In your March 9 letter to Mr. Richard Powers of my staff, you requested formal acceptance our your Brifen Wire Rope Safety Fence as an National Cooperative Highway Research Program (NCHRP) Report 350 test level 3 (TL-3) traffic barrier. To support this request, you also sent copies of two test reports prepared by the Motor Industry Research Association (MIRA) under the direction of Mr. Rex Hedges and video tapes of the two tests that were conducted. The test reports were entitled "Vehicle Impact into the Length of Need (LON) Of A Wire Rope Fence To NCHRP 350, Test Designation(s) 3-10 and 3-11 (MIRA-99-436008 and MIRA-99-436009). Additional information (installation manual) was sent to Mr. Powers on March 16.

Based on staff review of the information you provided, I concur that the 4-strand Brifen Wire Rope Safety Fence, as tested, meets all evaluation criteria for an NCHRP Report 350 barrier at test level 3 (TL-3) and it may be used on the National Highway System (NHS) when such use is proposed by the contracting agency. Since this product is made from steel and is proprietary, the provisions of Sections 635.410 and 635.411 of Title 23 Code of Federal Regulations are both applicabl

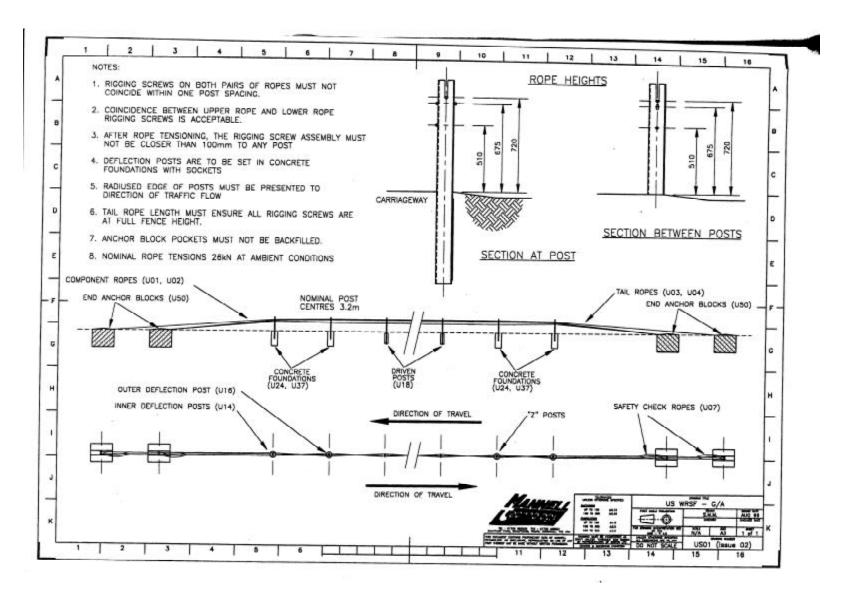
The Brifen Wire Rope Safety Fence test installation was approximately 109 meters long. Its four steel cables were supported on 1525-mm long S-shaped line posts with soil plates set on 3.2 meter centers. The posts were made from 6-mm thick galvanized steel (ASTM A709 Grade 36) and set in a compacted AASHTO Type M 147-65 soil. The top cable was set in a slot on the top of the posts at a height of 720 mm above the ground. The middle two cables were placed on either side of the posts at a height of 675 mm and crossed between each post spacing. The bottom cable was placed at a nominal height of 510 mm and was also intertwined between each post spacing. This cable positioning results in a symmetrical barrier that can be installed in a median for opposite direction traffic as well as on either side of a road as a roadside barrier. Once installed, the cables are tensioned to a specified degree, depending on the ambient temperature. This tension varies from 14.0 kN at 30 degrees Celsius to 36.0 kN at -10 degrees Celsius. This amount of tensioning is 4 to 5 times greater than that specified for the U.S. 3-strand cable barrier and accounts for the significantly reduced dynamic deflection noted in the Brifen crash tests as well as the reduced length of barrier damaged in a crash. Enclosure 1 is a drawing of the Wire Rope Safety Fence as tested.

For test 3-10, an 898-kg vehicle impacted the wire rope at 101 km/h and an impact angle of 20 degrees. Maximum occupant impact velocity was 4.6 m/sec and maximum ridedown acceleration was reported as 4.0 g's. Dynamic deflection was 1.04 meters. For test 3-11, a 1999-kg pickup truck impacted the barrier at 99.4 km/h at 26 degrees. Maximum occupant impact velocity was 3.4 m/sec and maximum ridedown acceleration was 2.8 g's. Dynamic deflection was 2.4 meters.

I understand that testing is currently underway to develop a crashworthy end terminal for this system. Until then, the current terminal design may be used if it is located beyond the minimum clear zone or shielded with an accepted device such as a sand barrel array. I have also been informed that you intend to test this barrier to test level 4 (TL-4) with the 9000-kg single unit truck and look forward to seeing the results of these two endeavors.
